**E4418B-08A-S**

# **S E R V I C E N O T E**

## Agilent E4418B EPM Power Meter

## Correct Orientation of the Power Supply's Force-fit Connector

Figure 3: Correct orientation of force-fit connector.

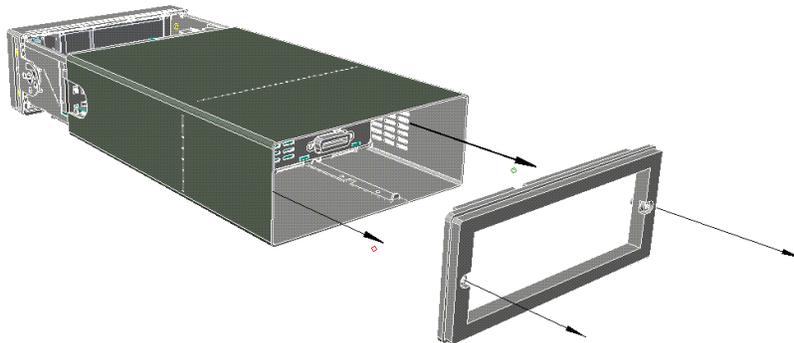
It has been highlighted that the force-fit connector connecting the earth wire to the Power Supply Unit, (P/N: 0950-3681) can be fitted in two different ways on the E4418B.

By fitting the connector with the bottom (flat) side facing the large capacitor on the Power Supply Unit, the gap between them is maximized (approximately 2mm).

By fitting the connector with the top (rounded) side facing the large capacitor on the Power Supply Unit, the gap between them is minimized (approximately 1.2mm).

The gap should be maximized at all times to ensure the unit meets the design and regulatory requirements relating to electrical insulation. This requirement is such that the gap should be at least 1.71mm.

Ensure that this connector is re-fitted such that the bottom (flat) side of it is facing the large capacitor on the Power Supply Unit, P/N: 0950-3681.

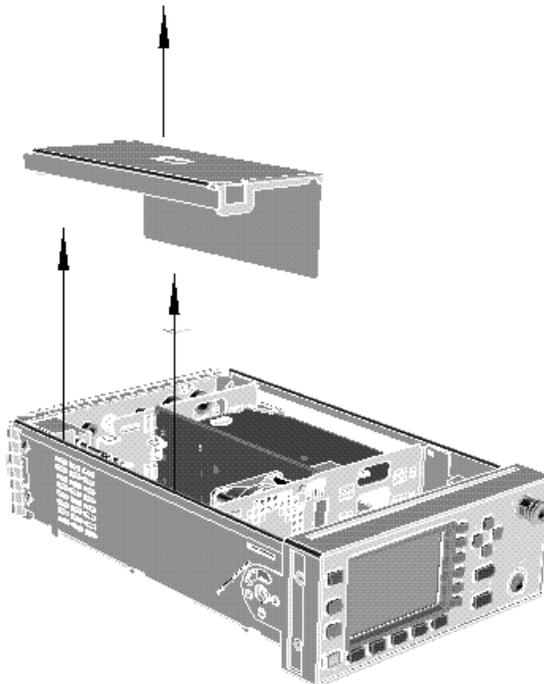
1. Remove the optional battery if fitted before removing the cover as shown below.

2. Remove the power supply cover by lifting it out as shown below.

3. Check if the bottom (flat) side of the force-fit connector is facing the large capacitor on the Power Supply Unit, P/N: 0950-3681.
